Maxtor Corporation  
500 McCarthy Boulevard  
Milpitas, CA 95035 USA

To: T10 SAS Protocol Working Group  
Contact: Mark Evans  
Phone: 408-894-5310  
Email: mark\_evans@maxtor.com  
Date: 23 February 2004

Subject: SAS-1.1, adding the Terminate Data Transfer protocol service

Figure 5 — ST\_I (transport layer for SSP initiator ports) state machines

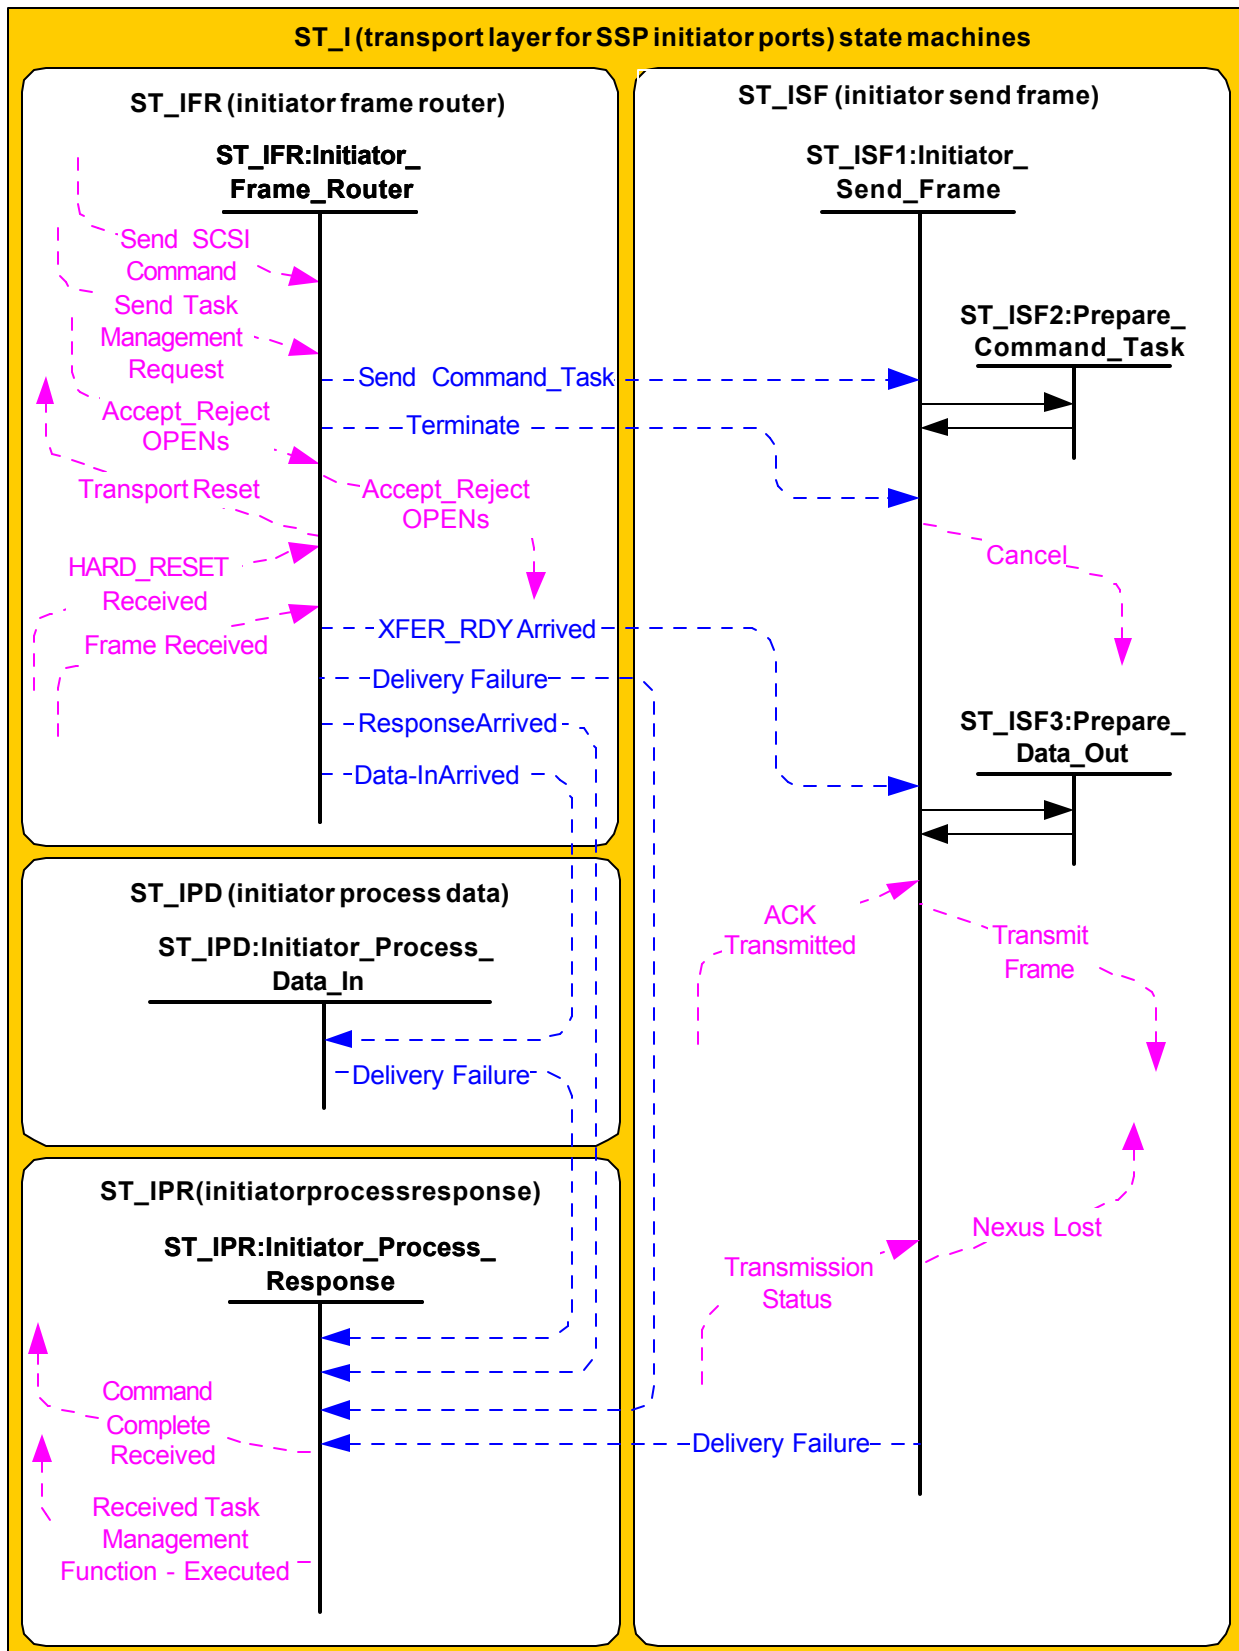
| [update the following figure.](#)
